Authors' reply to Editor and Referees "Heterogeneity measures in hydrological frequency analysis: review and new developments" by A. I. Requena et al.

Heterogeneity measures in hydrological frequency analysis: review and new developments

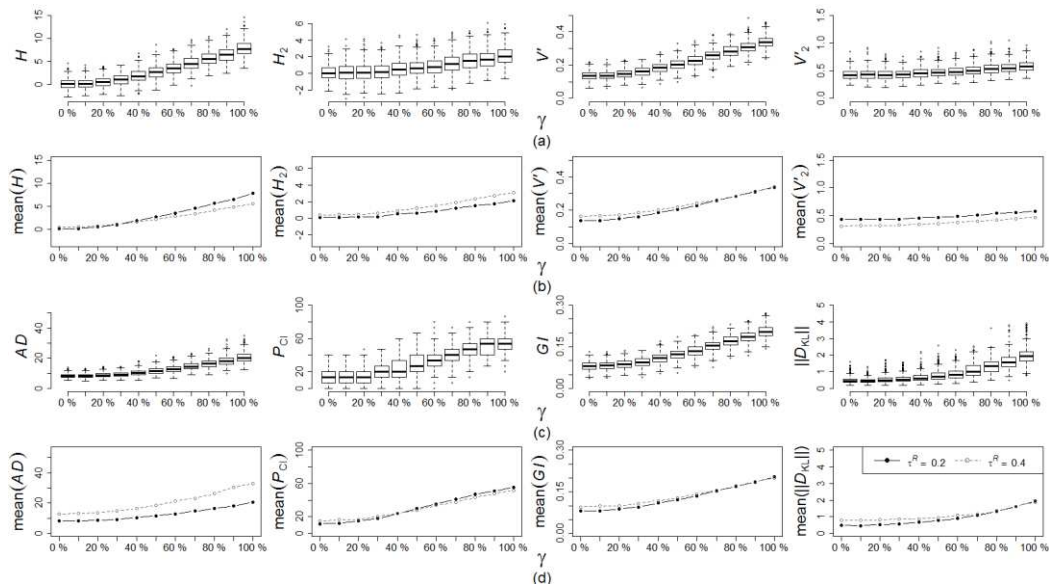
7. In Figure 7, impact of heterogeneity due to addition of discordant sites to homogeneous regions is presented. A similar observation can be concluded from Figures 1 where the indices are assessed with increase in the heterogeneity percent (gamma value). In the case of Figure 1, mean of conventional heterogeneity measures (H1, H2, AD) tend to diverge with increase in the degree of heterogeneity while in Figure 7, Heterogeneity measures tend to converge (coming close) with increase in the number of discordant sites (i.e. increase in the degree of heterogeneity). Kindly clarify this point. However, in the case of GI, in both figures 1 and 7, convergence is visible. Why is this happening?

Reply: It is important to highlight that, although both graphics have in common an increase in the regional heterogeneity, their characteristics and displayed information are different. In the case of Fig. 1, heterogeneous regions with increasing heterogeneity (from 0% to 100%) are generated by considering two different regional L-CVs and their heterogeneity values are compared. As a result, measures such as H1 and H2 “diverge” with increasing heterogeneity, as these measures are not originally thought to compare several (heterogeneous) regions. In the case of Fig. 7 the situation is different. A given homogeneous region is considered, and “homogenous” sites are exchanged by “discordant” sites. Hence, in this case, progressive changes in the heterogeneity of a given region are assessed (not between different regions). As a
